**RE: SUBMISSION ON THE METROLINK ON BEHALF OF WYNN'S HOTEL, 35-39
ABBEY STREET LOWER, DUBLIN 1, D01 C9F8**

ABP Ref. NA29N.314724

Project Title	Project Metrolink – Wynn's Hotel Dublin	From	Robert Coughlan, PUNCH Consulting Engineers
Project No	222266	To	An Bord Pleanála
Subject	Technical Submission to Railway (Metrolink–Estuary to Charlemont via Dublin Airport) Order 2022 at – Wynn's Hotel Dublin, 35-39 Abbey Street Lower, North City, Dublin 1, D01 C9F8	Cc	
Date	12-01-2023

**Appendix B- Volume 4, Chapter 20- Fig 20.16, sheet 29
of 30**

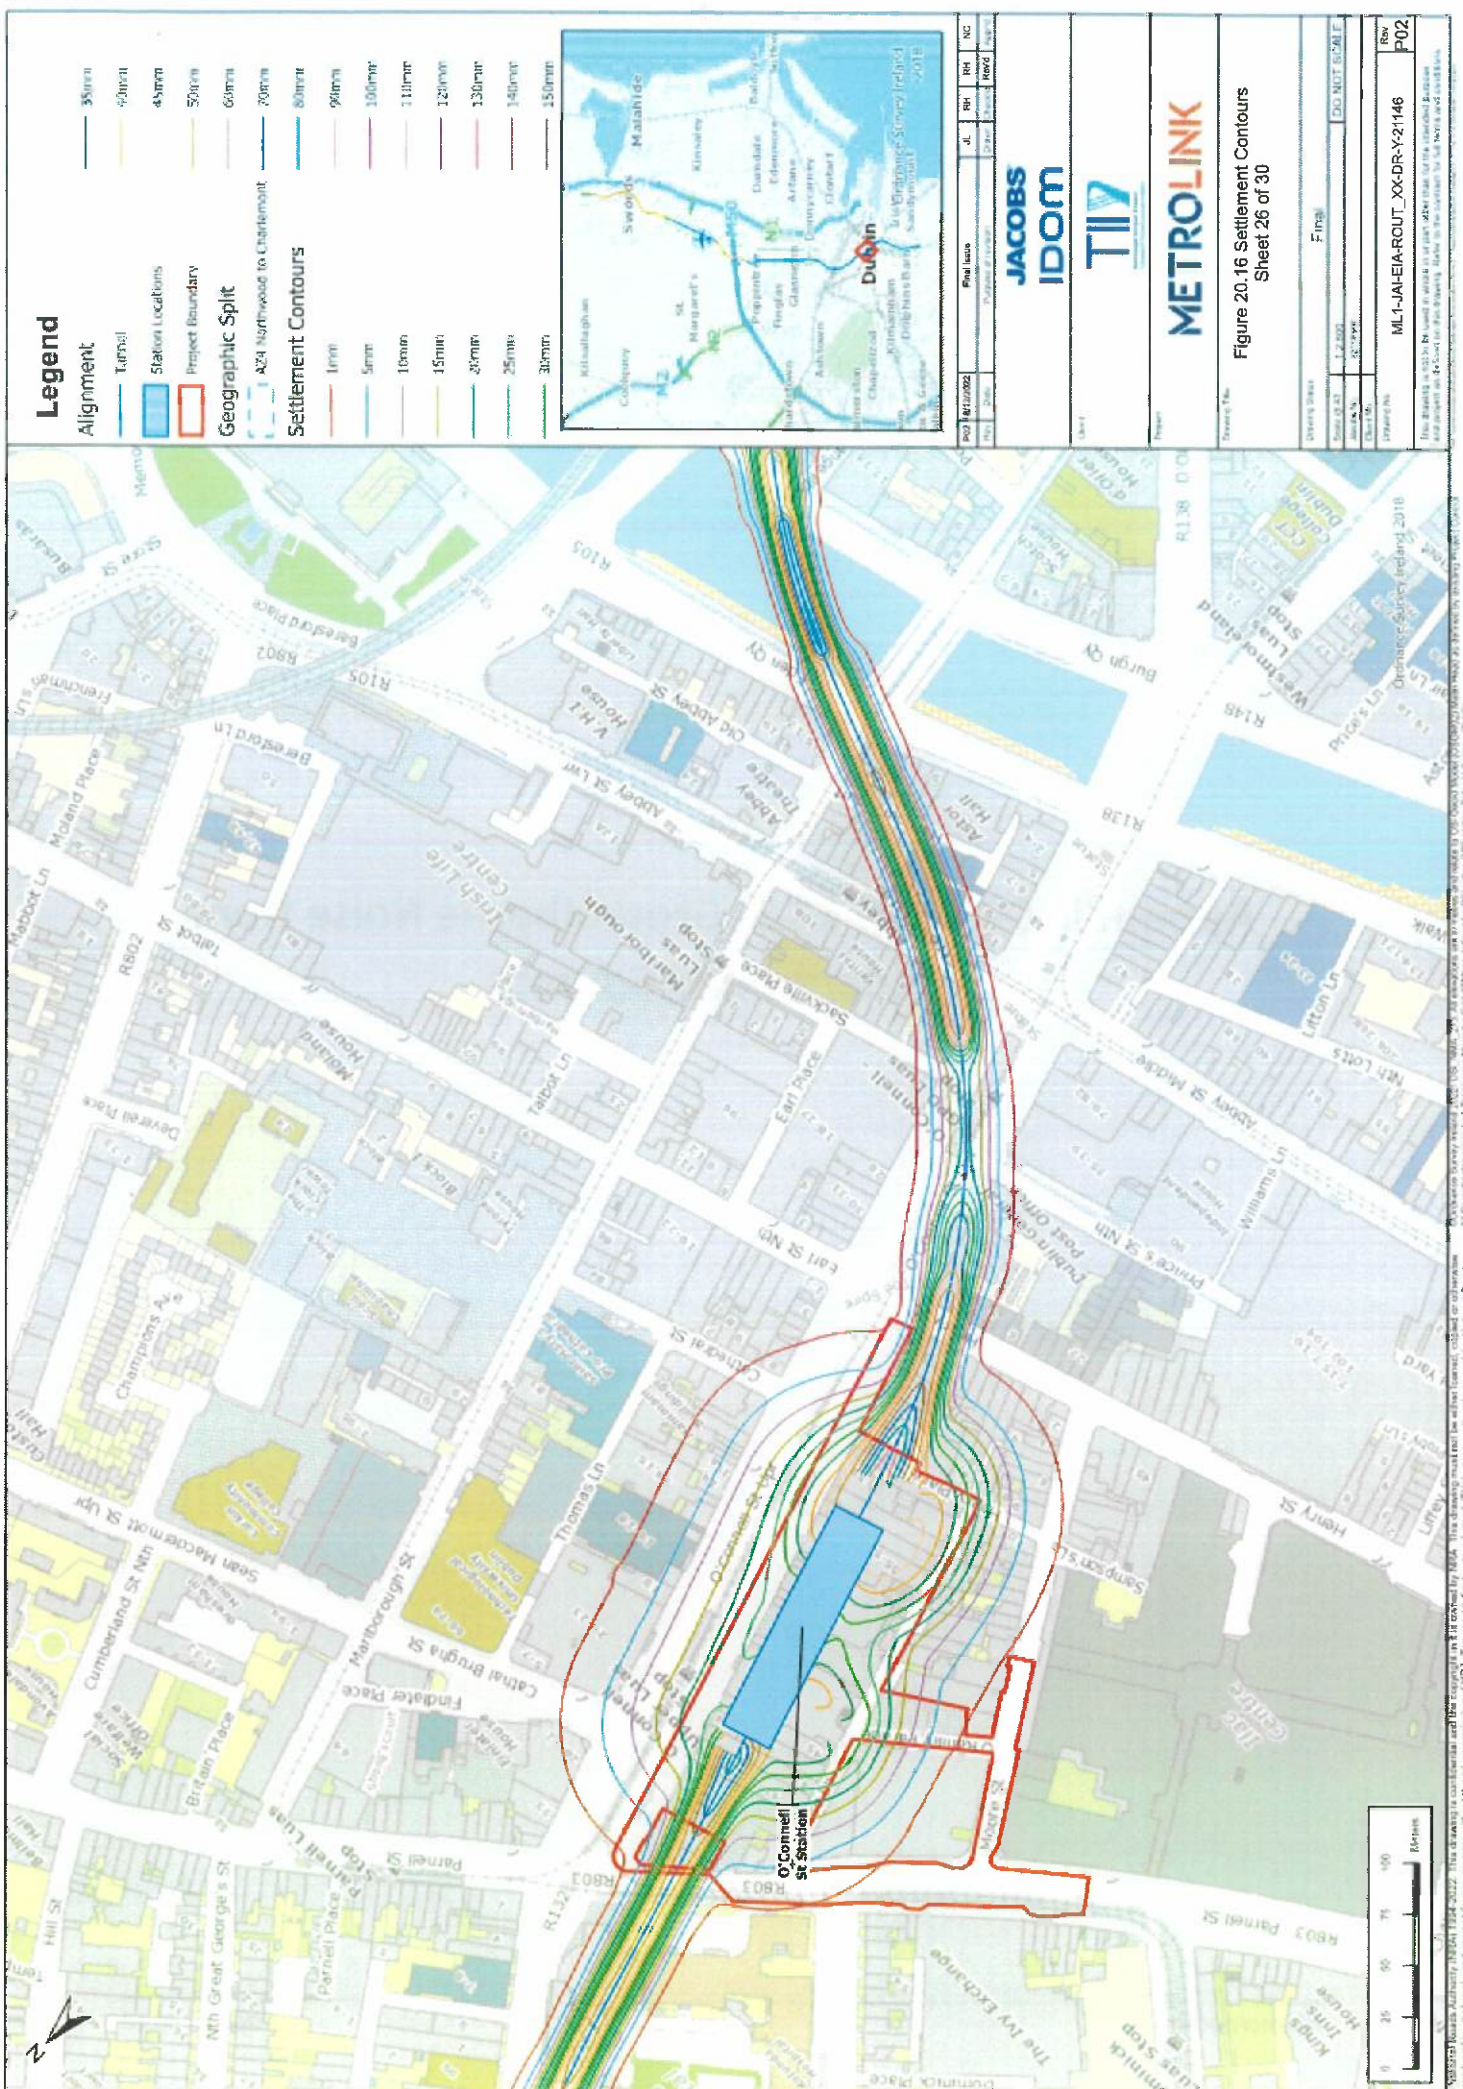
- i) The predicted settlement is a concern from available information on <https://www.metrolinkro.ie/>. The settlement contours on Figure 20.16, sheet 26 of 30 (Refer to Appendix B), suggest settlement of 40-45mm in the calculated settlement trough. We request details from TII on how they established this deflection data. The building is a Protected Structure and over 170 years and TII must recognise this.
